**WATER RESOURCE
DEVELOPMENT PROJECT**
CHANNEL REHABILITATION PROJECT
LOCAL PROTECTION

DESIGN MEMORANDUM NO. 1

DAEN-CWE-BB (NEDED-E, 9 Dec 77) 1st Ind
SUBJECT: Channel Rehabilitation Project, Local Protection, North
Nashua River Basin, Fitchburg, Massachusetts; Combined
General Memorandum No. 1, Phase I - Plan Formulation and
Phase II - General Design

1. The subject design memorandum is approved, subject to the comments in the following paragraphs.
2. The local cooperation requirements on page 6 should quote verbatim the requirements as stated in the Senate Document 113, 89th Congress, 2nd Session, North Nashua River and tributaries, Merrimack River Basin, Massachusetts, 6 October 1966 (see ER 1110-2-1150, Appendix A, paragraph 2a). The local cooperation requirements on page 63 should be modified by ~~the~~ adding to the hold and save clause (paragraph b) "except damages due to the fault or negligence of the United States or its contractors," as required by Public Law 93-251. The formal local cooperation agreement wording of the local cooperation requirements must be in strict conformance with the project document wording as modified by Public Law 93-251.

KEY

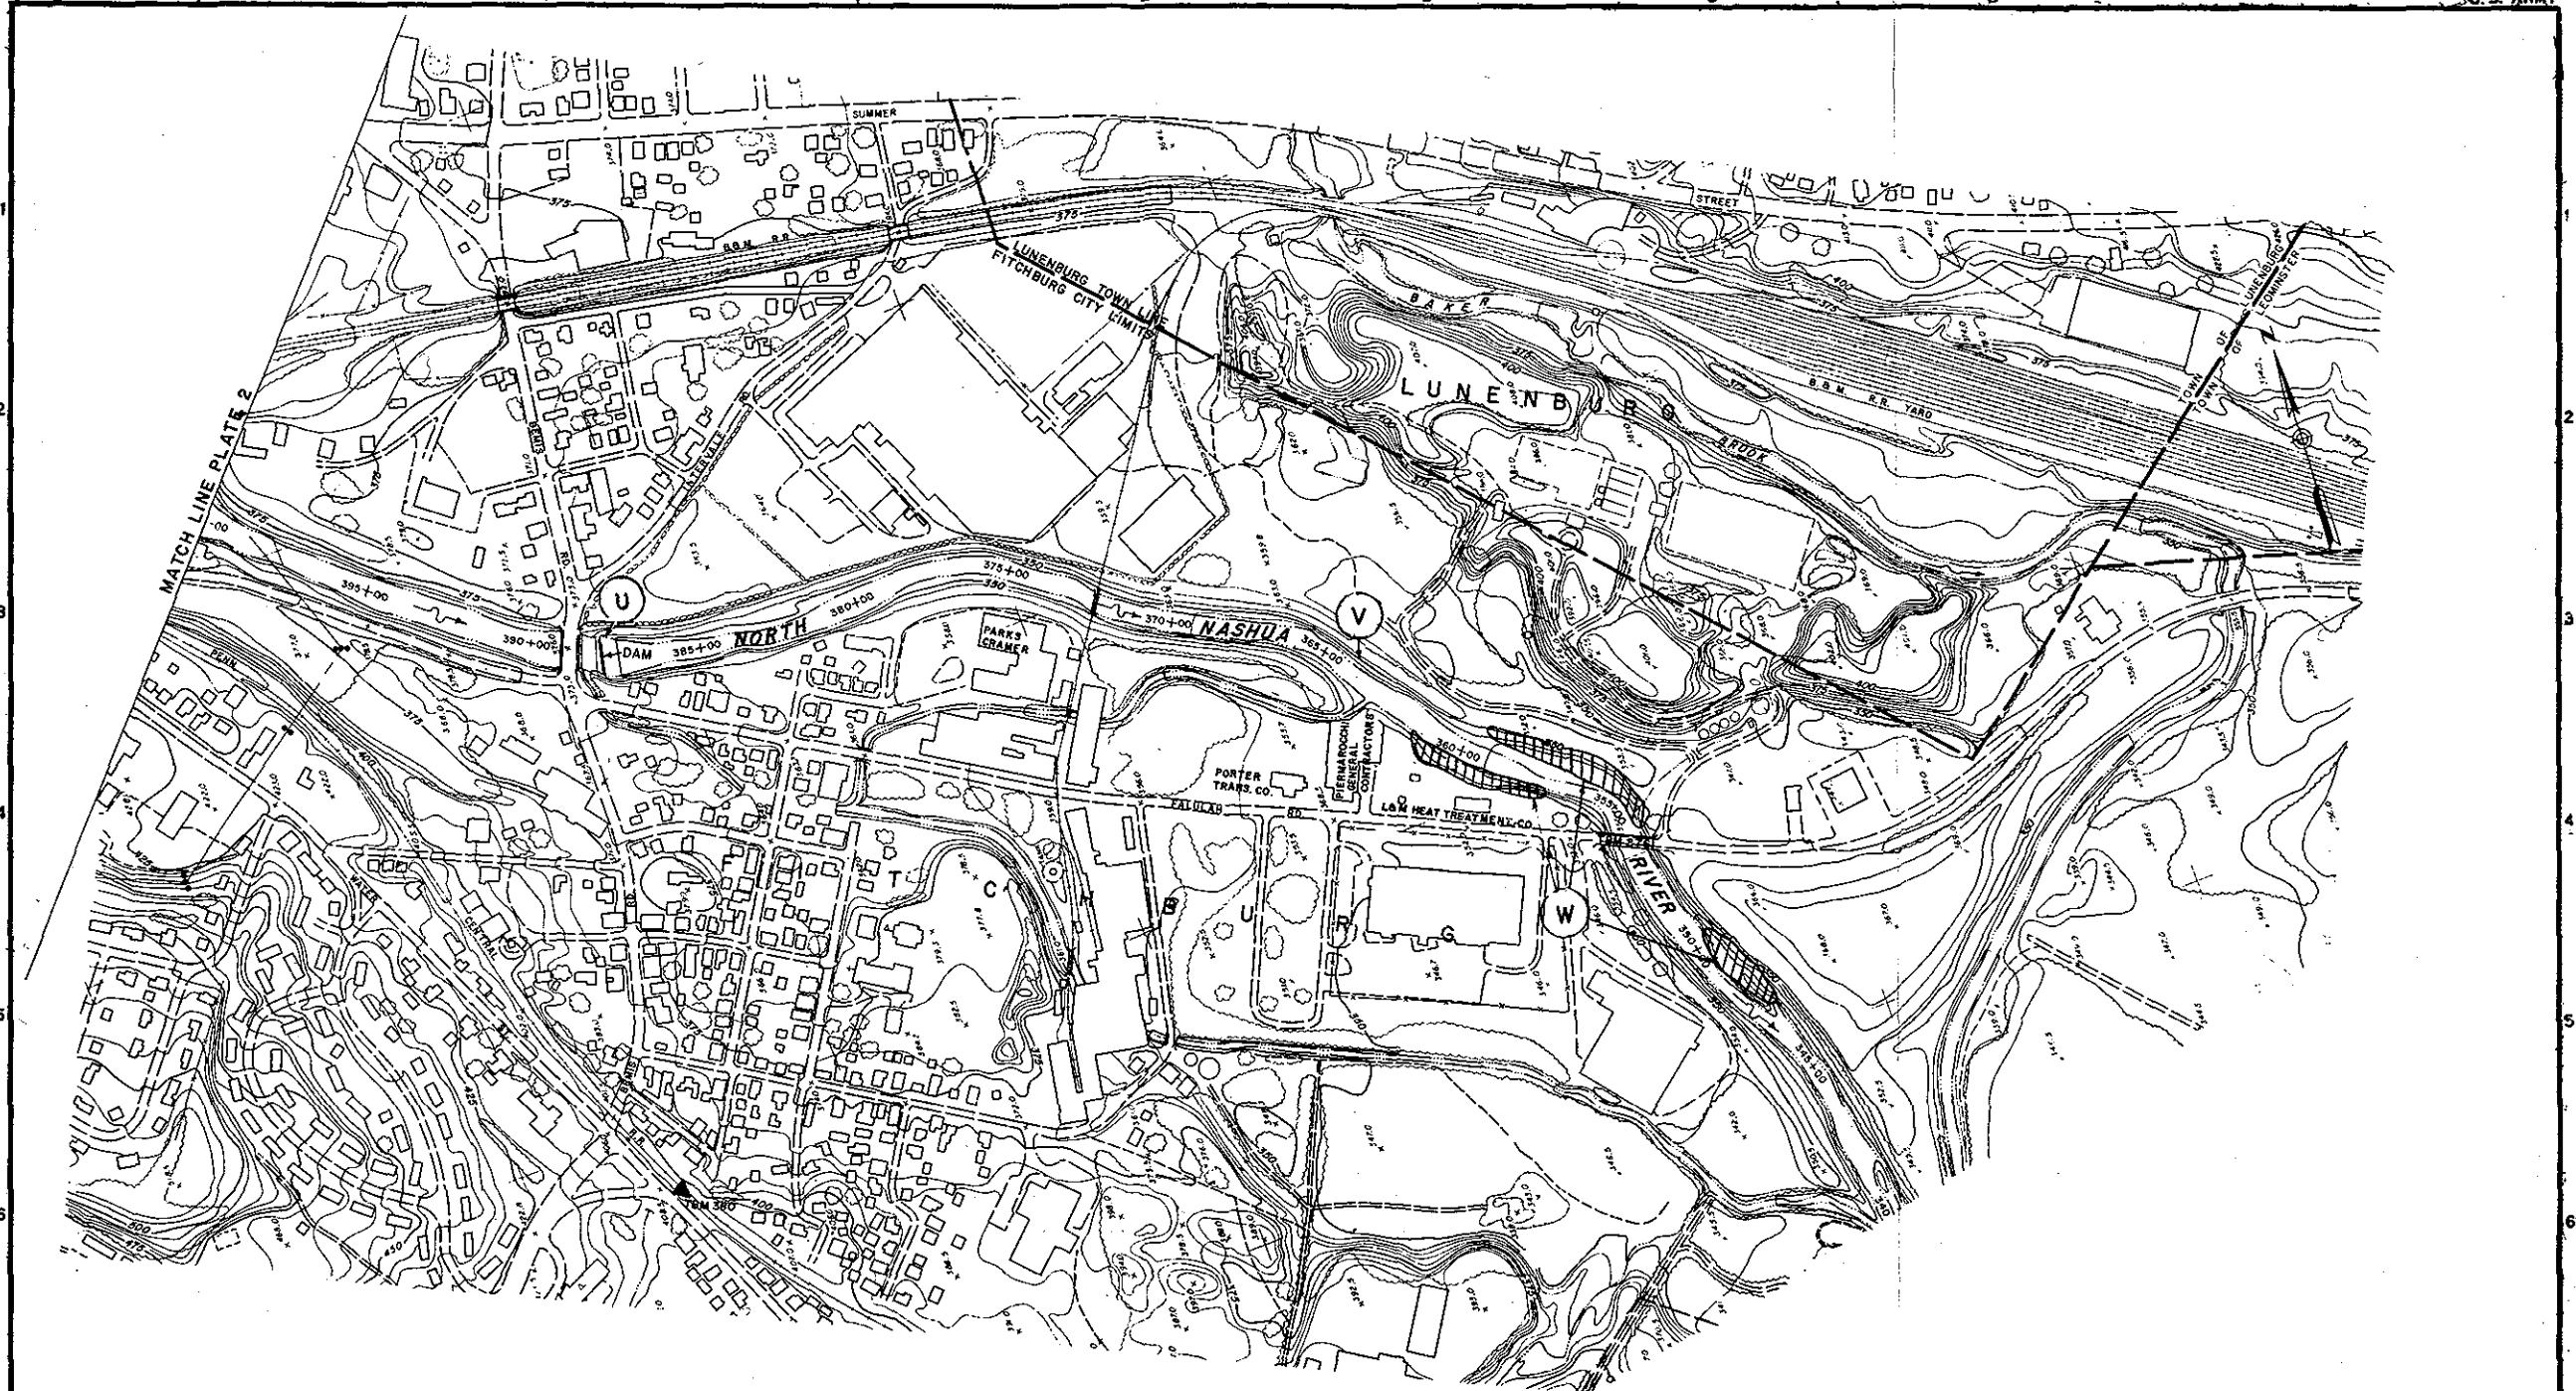
3. Plates 1, 2, and 4. Plans and specifications should provide for positive drain measures where cut stone or riprap is to be grouted.
